LEVEL 12 CONDENSATE SENSOR MARKUP
AGC-8532-SK-LEVEL 12 CONDENSATE SENSOR
MARKUP-161020
Rev 1 - NM - 05/10/2016
Rev 2 - NM

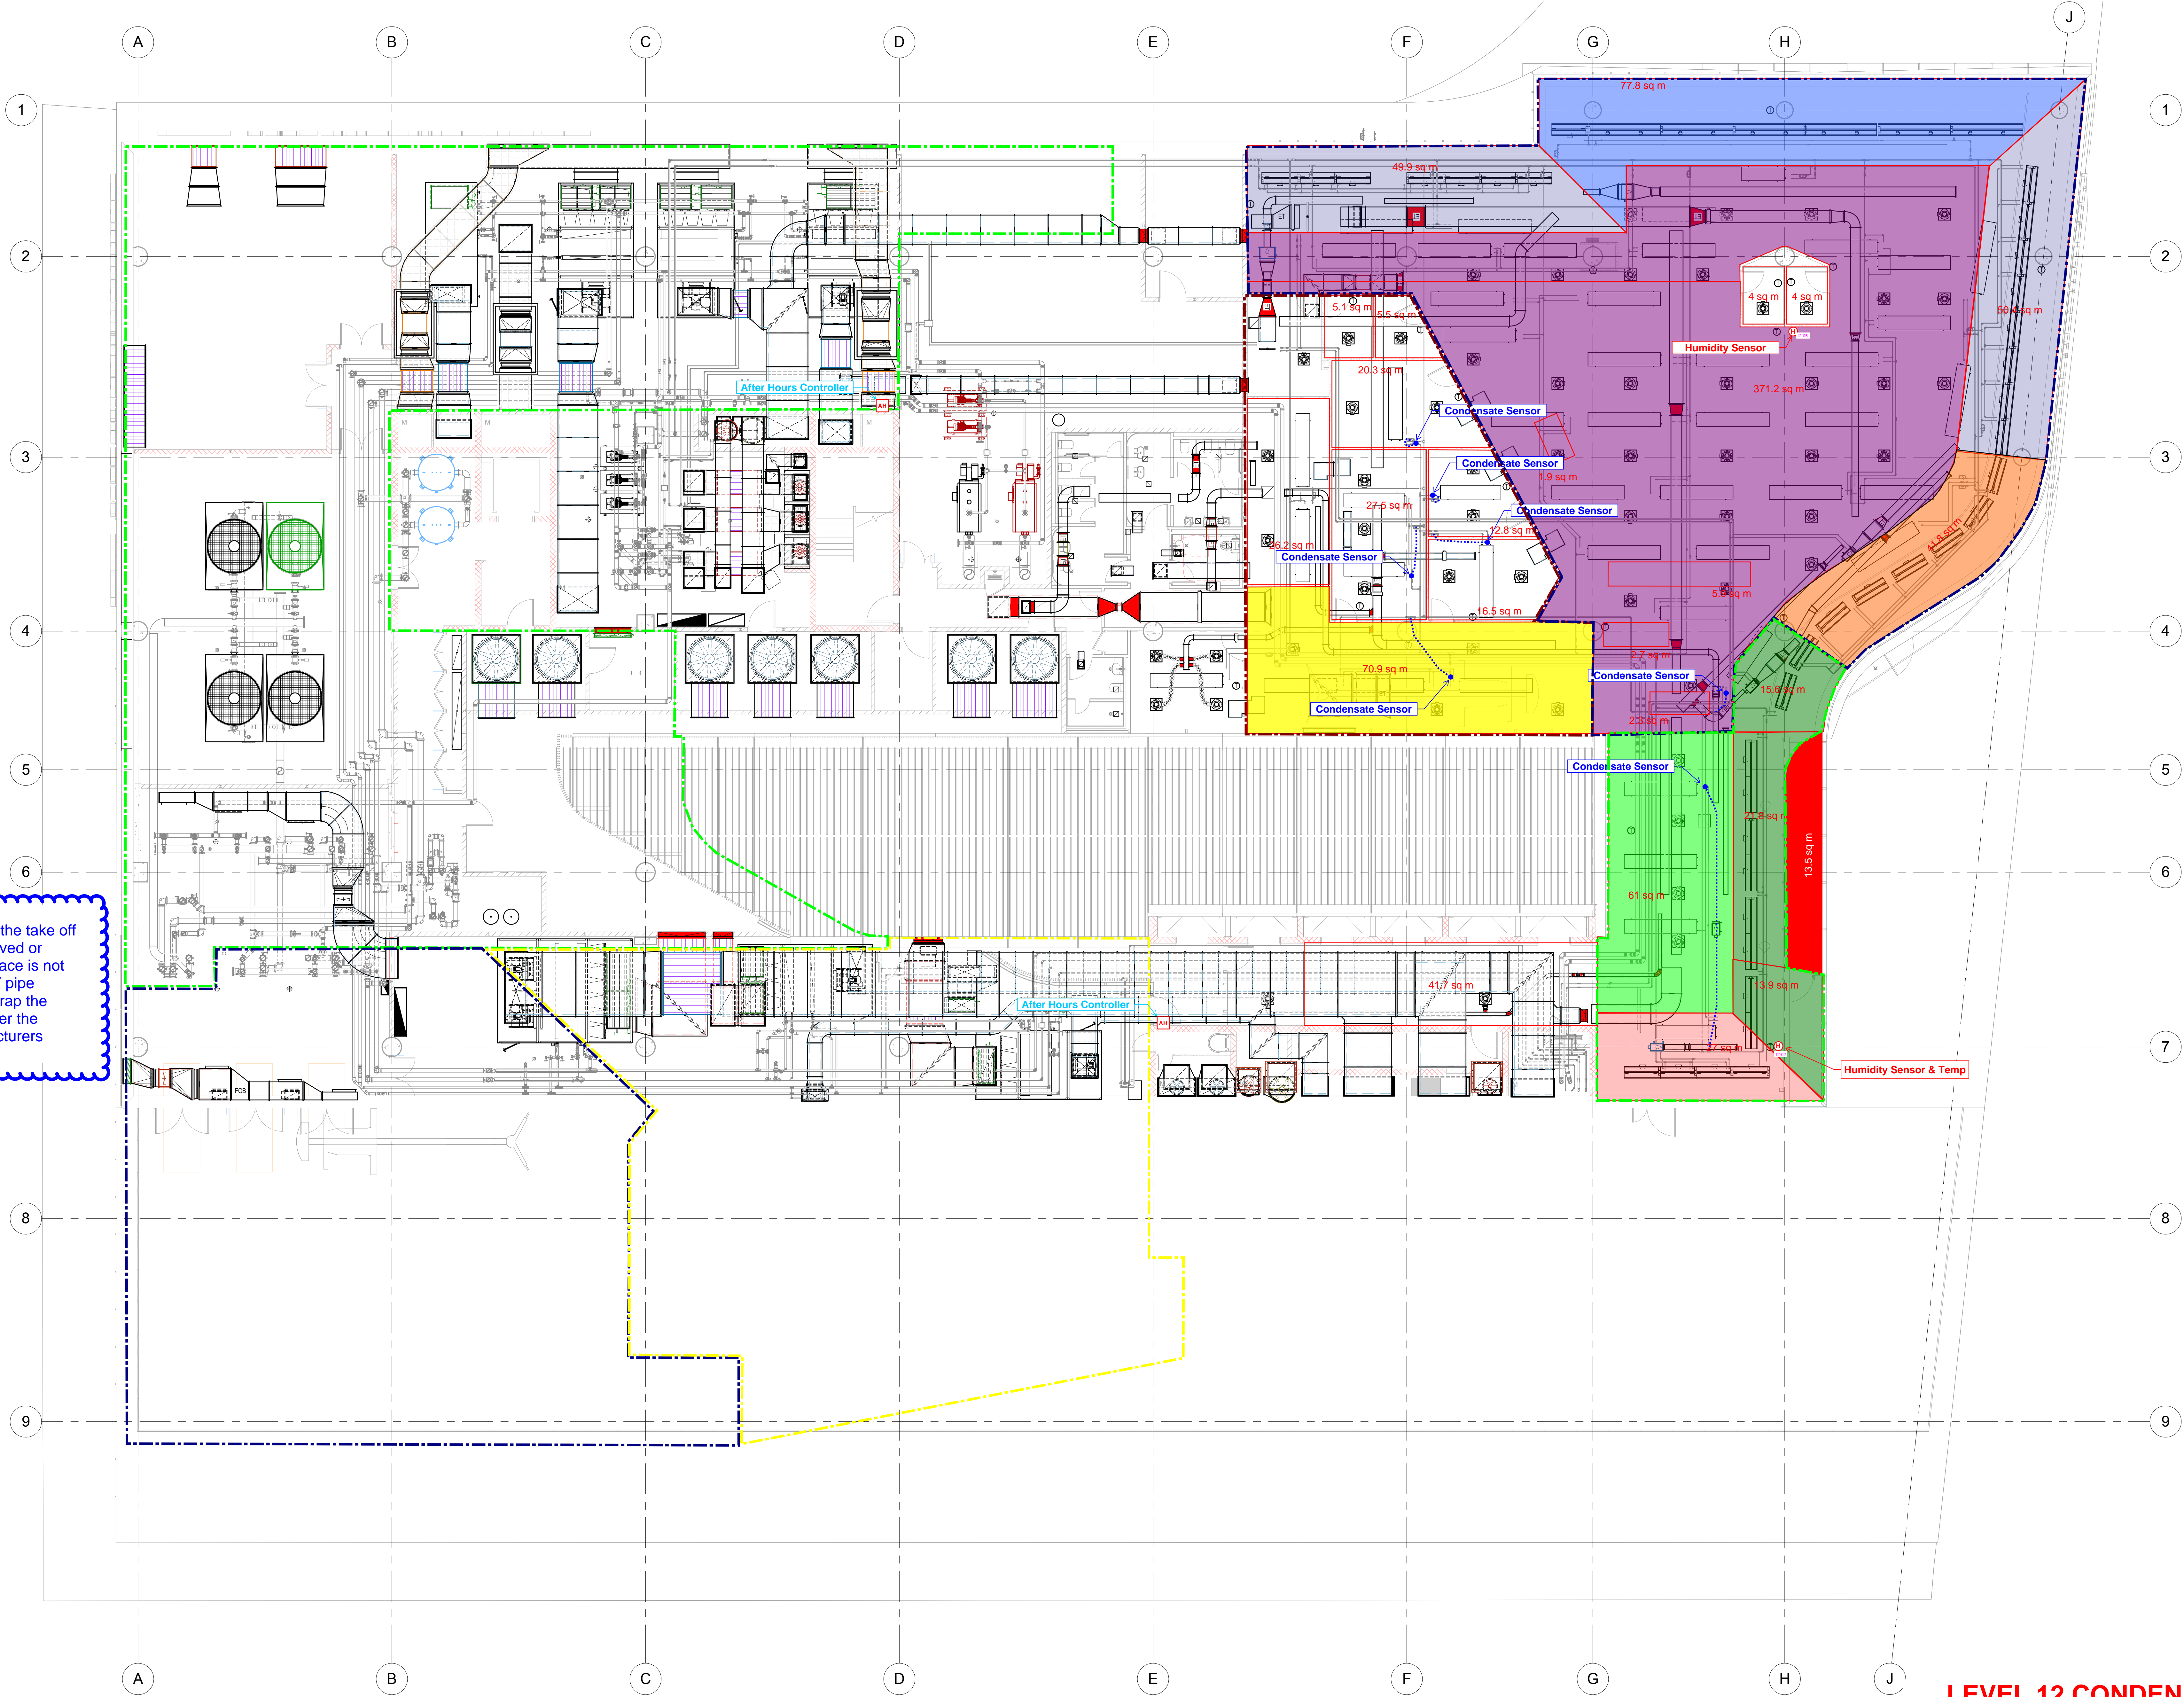
Typical
The condensate sensors at the take off for the first chilled beam served or adjacent to the take off if space is not permitted. Expose the CHW pipe insulation for 100mm and strap the sensor. To be installed as per the condensate sensor manufacturers specification.
